# Technical Note

**Project:** Rudloe Drive, Quedgeley

**Subject:** Drainage strategy

<b>Client:</b>	Linden Homes	<b>Version:</b>	0.0
<b>Project No:</b>	06396	<b>Author:</b>	[REDACTED]
<b>Date:</b>	15/07/2022	<b>Approved:</b>	Daniel McCrudden

**Area Contribution Plan**

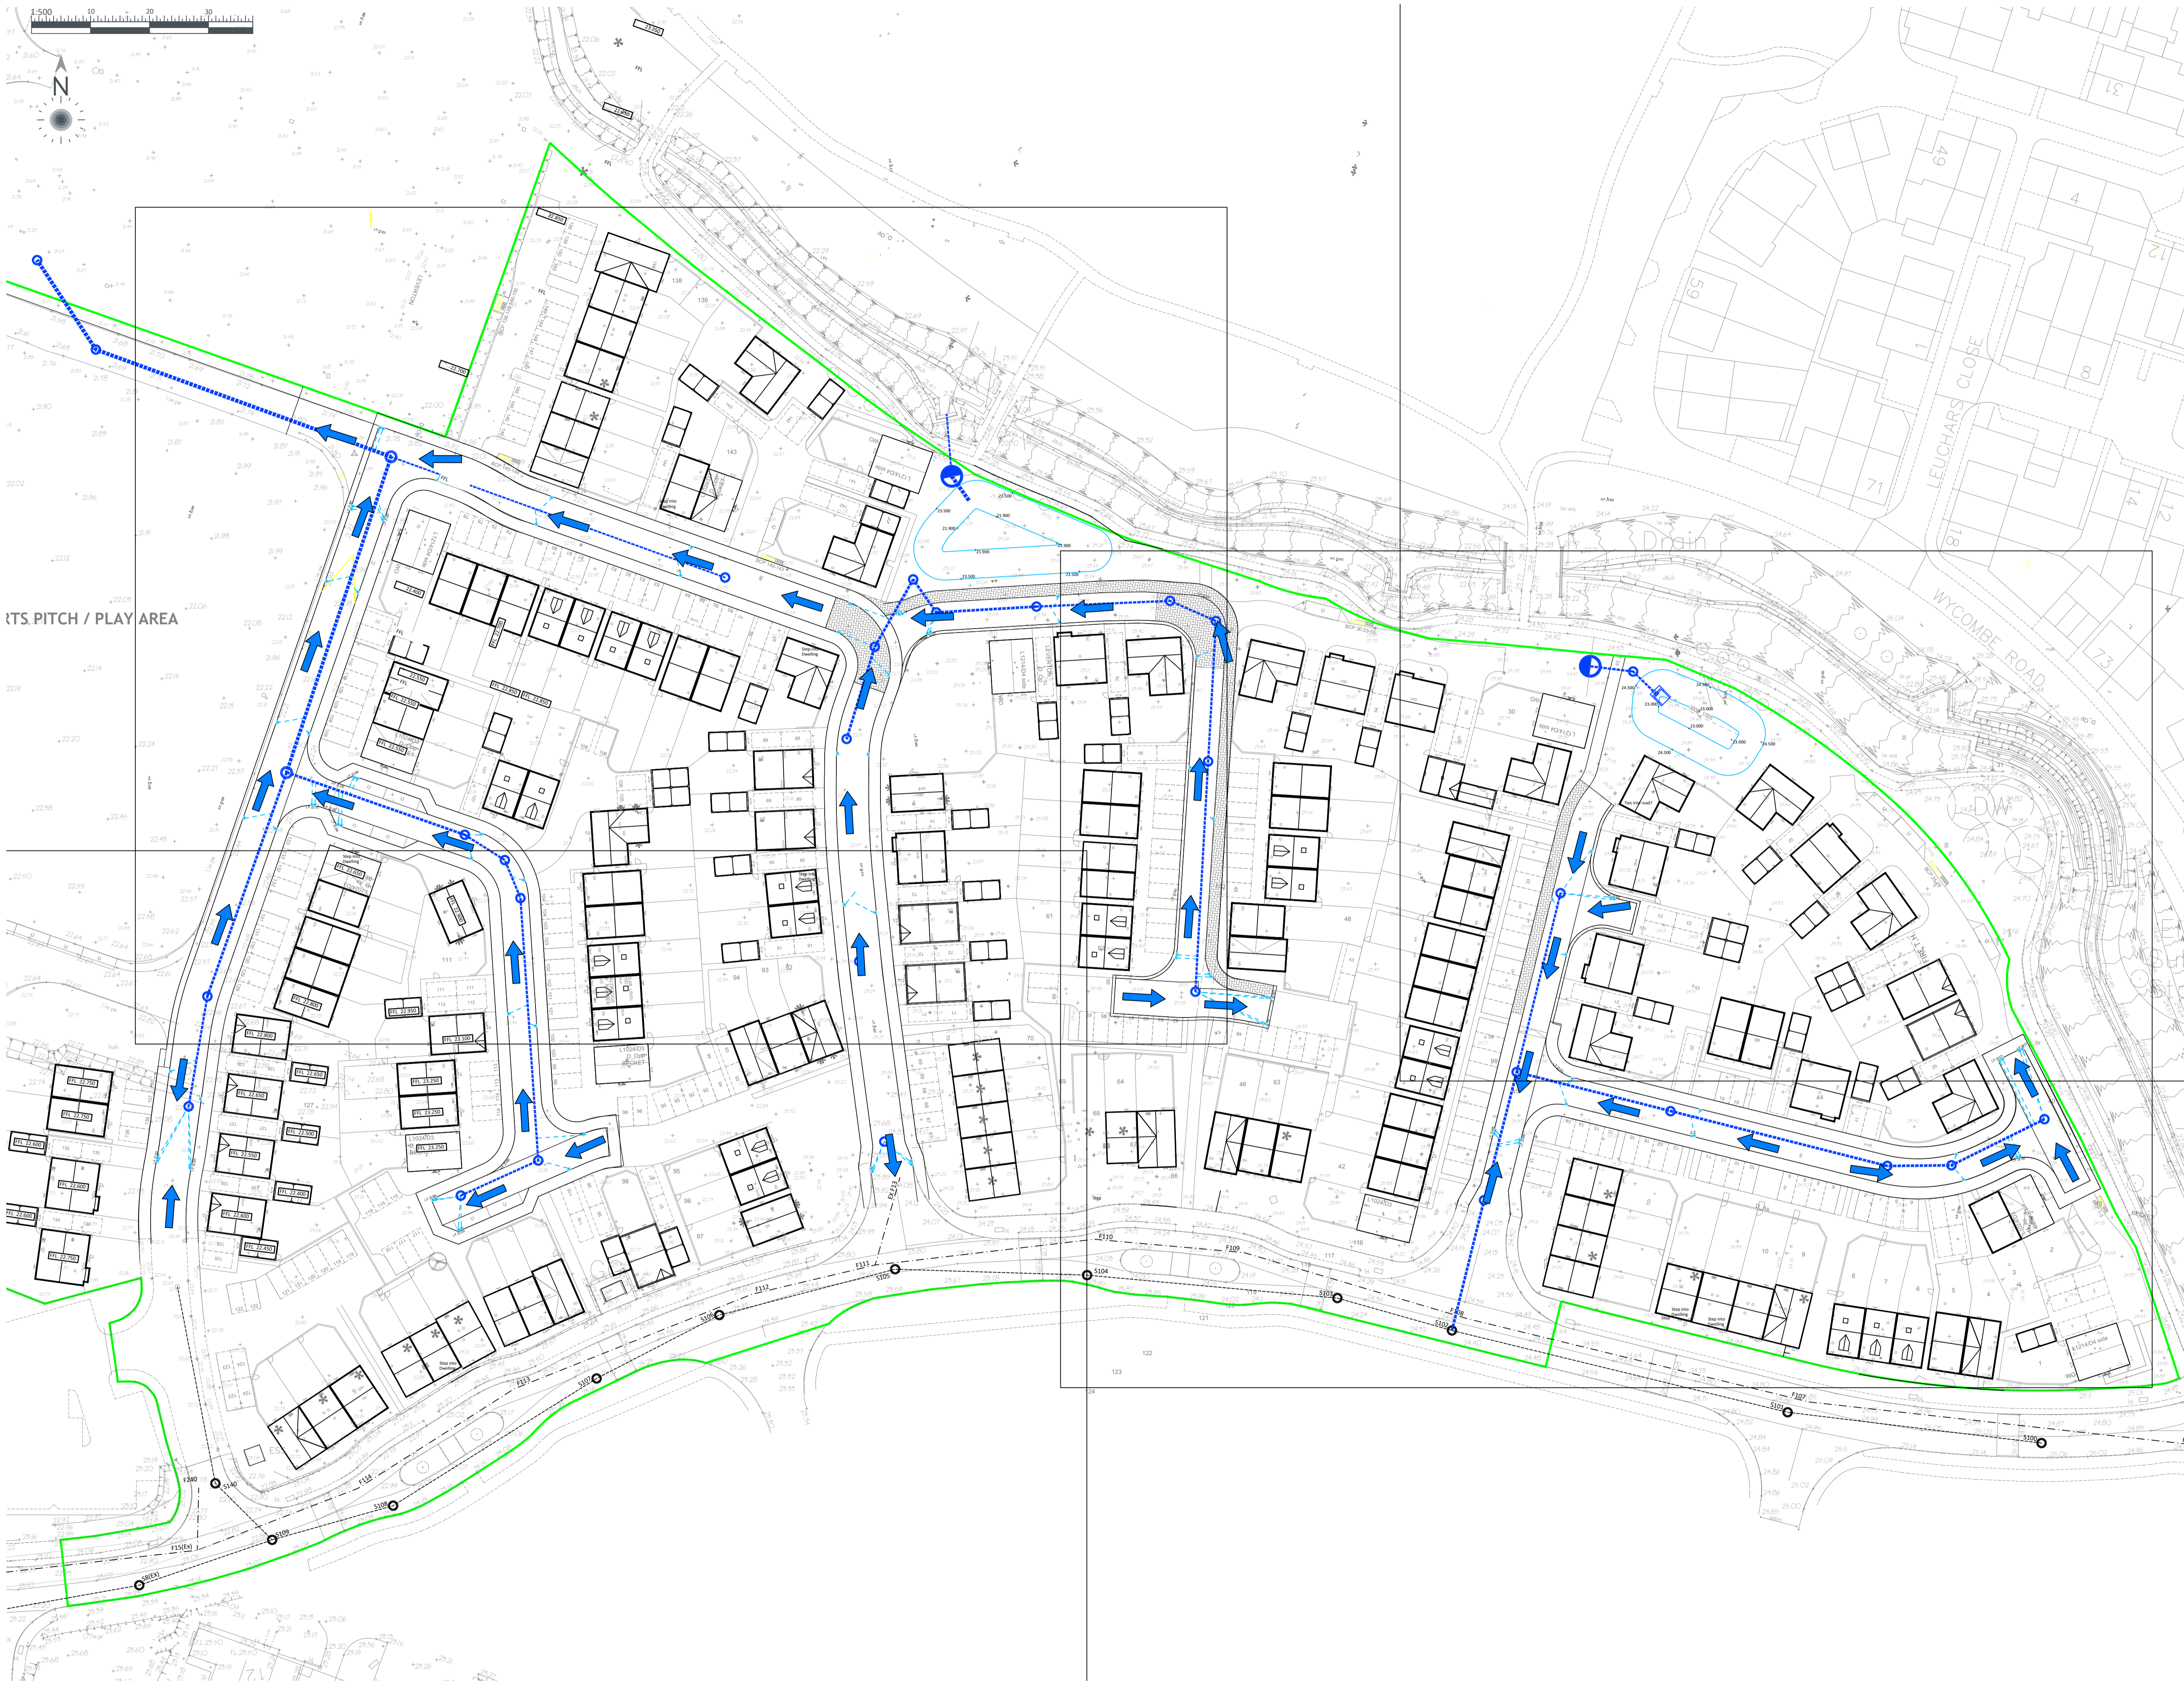
The LLFA objection, as quoted below, refers to the attenuation capacities of the two basins on site and how they are smaller than the volumes quoted on drawings previously submitted during the outline planning application stage.

*“This application refers to the reserved matters for planning consent 21/00490/OUT. That application showed the site developed in a way that required two attenuation basins with a total capacity for a volume of 432m<sup>3</sup> such that surface water could be discharged to the adjacent watercourse at 24 l/s. The plan submitted for this application only provides*

*attenuation storage capacity of 347m<sup>3</sup> to discharge surface water to the adjacent watercourse at 24 l/s. It is not clear where the layout offers any ability to reduce the attenuation storage capacity by 22%.”.*

The proposals, like the outline strategy, utilise the three outfall locations specified in the site wide drainage strategy from the FRA. The drained impermeable areas used however, reflect the exact areas shown on the site layout plan. The catchment area split can be seen on PJA drawing 0405-P1, included within Appendix E.

The total impermeable discharged to the existing network by this location is 1.607 ha compared with an allowable 1.820 ha.
